Please find attached the Towns of Portola Valley, Los Altos Hills and Woodside's response to the May 2016 FAA report entitled "Northern California Initiative – Executive Summary – Feasibility Study." Our communities appreciate the opportunity to comment on the report and provide our collective response.

Analysis of the portions of the FAA initiative to Address Noise Concerns of Santa Cruz/Santa Clara/San Mateo/San Francisco Counties, Compiled at the Requests of Representatives Farr, Eshoo and Speier relative to aircraft landing at San Francisco International Airport (SFO). Phase One actions.

Prepared by Williams Aviation Consultants at the request of the Towns of Portola Valley, Los Altos Hills and Woodside.

Figure E.1: Comparison of how the BSR and the SERFR were flown

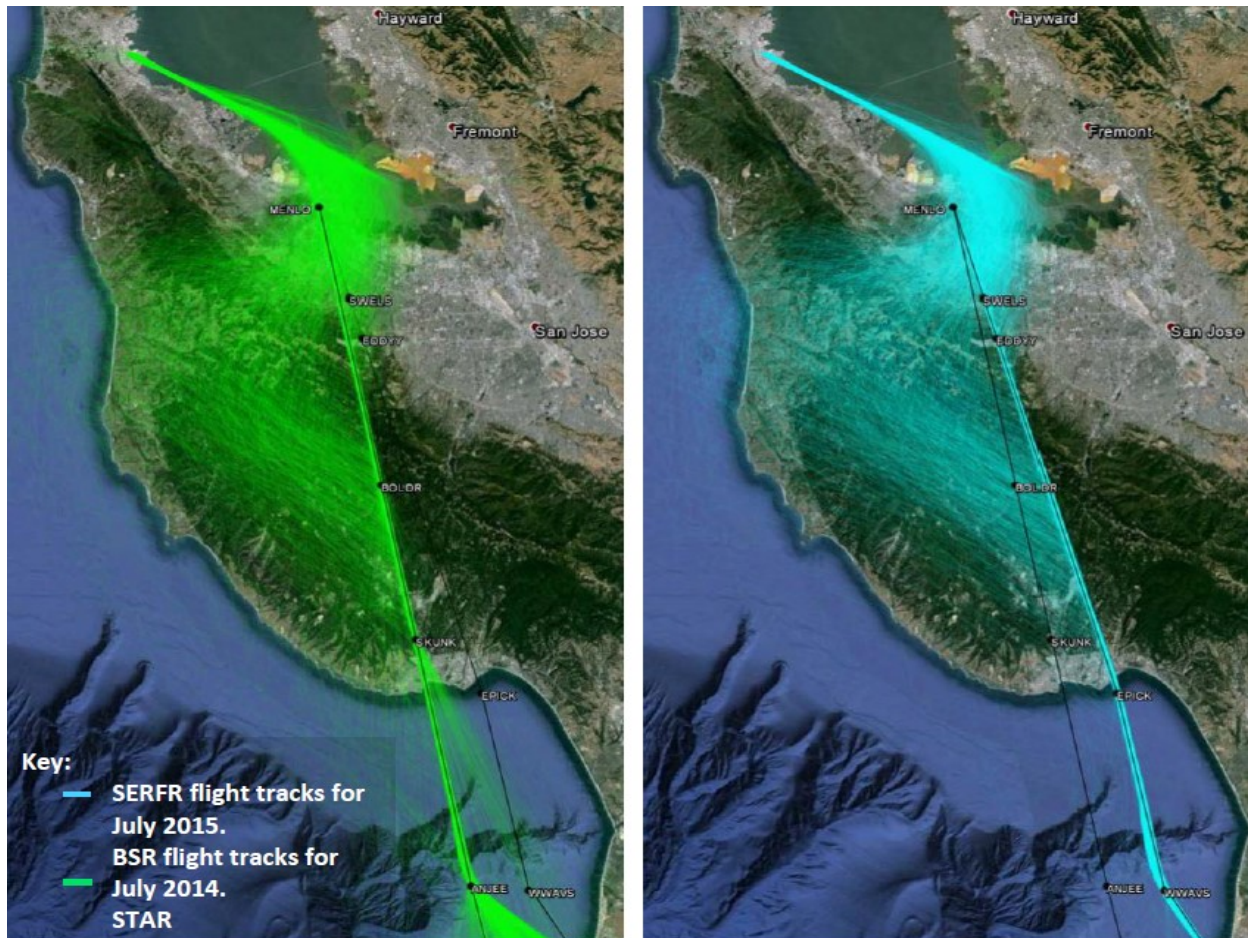
The second proposal involved developing PBN procedures which would disperse flights over a wider area. This includes parallel routes. The FAA rejected this proposal because dispersion of flight is already occurring. The FAA states: “in order to accommodate the volume of traffic merging into the Bay Area airports without increasing ground delays, traffic is typically vectored off their respective procedure”. Many peninsula towns and cities have identified the aircraft being vectored as the primary source of the increased noise they are experiencing. While the FAA appears to admit this activity is occurring, they refuse to discuss or analyze any possible solution. While the vectoring of aircraft may cause some dispersion, if aircraft are routinely and repeatedly placed over the same communities, it can hardly be called equitable. **Figure E 1** in the appendices, shown below, depicts the tracks of those aircraft receiving vectors. Every aircraft is vectored west of the published route. If this was truly equal distribution, some aircraft would be vectored east of the published procedure.

The idea that 17% of oceanic arrivals cross Woodside VORTAC below 8000 feet is unacceptable to the residents impacted by these aircraft. The ATC facility has in place a local requirement that 8000 feet is the minimum altitude for oceanic arrivals over Woodside. The fact that some airlines prefer to use an unpublished procedure that is in conflict with local criteria is not justification for the FAA to allow it to occur. The statement that “for safety reasons it is not feasible to raise these arrivals to 8000 feet MSL” is false. A review of this issue is certainly feasible. In addition, the Town of Woodside is impacted by many of those aircraft being vectored off the SERFR STAR (see **Figure E. 1**).
